Service Bulletin

Title: Heat Related Control Faults

Number: SB0006 **Date:** March 30, 2006

Product Identification: PCNC 1100 Milling Machine – Serial Numbers 38 and Lower

Machine Control Board PN 30163
Arrow indicates position of REG1 and REG2. This image is before heat sink has been added.

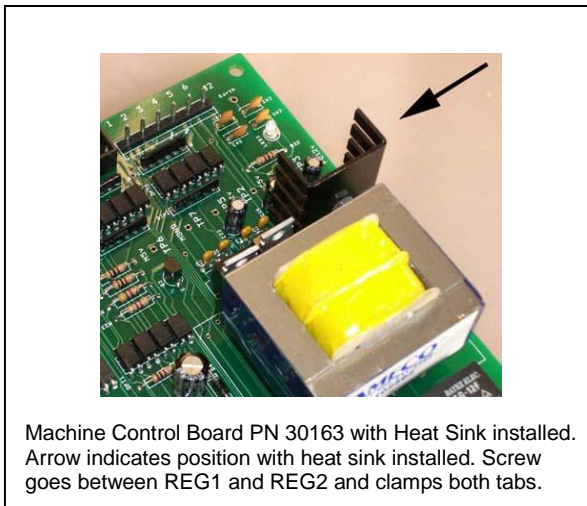
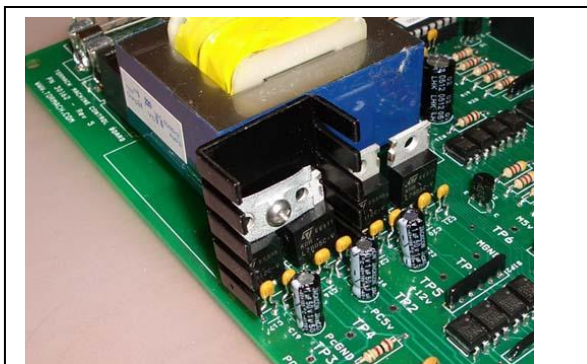
A few machines have displayed a behavior of spindle speed variation or spindle shutdown after running for a period of time. When this occurs there are no yellow or flashing red LED fault indicators on the spindle driver. The problem may be associated with a clicking noise emanating from machine control board to the left of the spindle drive. When the machine is turned off and some time is allowed, normal operation can be restored on a restart.

The issue has been traced to a thermal overload of a 5 volt regulator on the machine control board (PN 30162). The solution is the addition of a simple heat sink. The heat sink should be attached between components marked REG1 and REG2, as shown in the photographs on the following page. Heat sink compound is not necessary. It is important that the heat sink does not contact the metal tab of the adjacent regulator or the metal body of the nearby transformer. If your PCNC mill experiences this problem, please contact Tormach and request the controller heat sink kit.

Machine Control Board PN 30163 with Heat Sink installed.
Arrow indicates position with heat sink installed. Screw goes between REG1 and REG2 and clamps both tabs.

Here the heat sink is in place
